## Retrofit Rev. A LightSync Touch Screen Station To Rev. B TSS Wiring Details

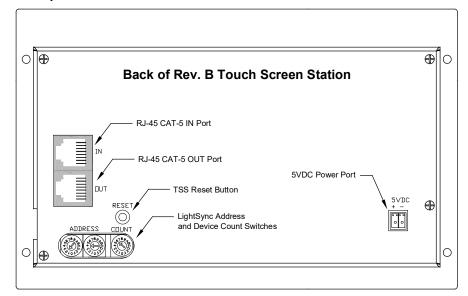
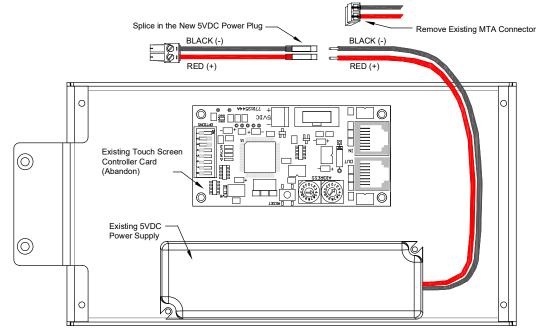
- 1. Power down the circuit to the 5VDC power supply.
- 2. Cut off the MTA connector from existing 5VDC leads.
- 3. Strip the ends of the wire and crimp on new leads, red to red, black to black.
- 4. Move LightSync CAT-5 data cables from controller card in the enclosure to the new touch screen.
- 5. Set LightSync address and switch count on touch screen to match existing settings on controller card.
- 6. Power-up and test.
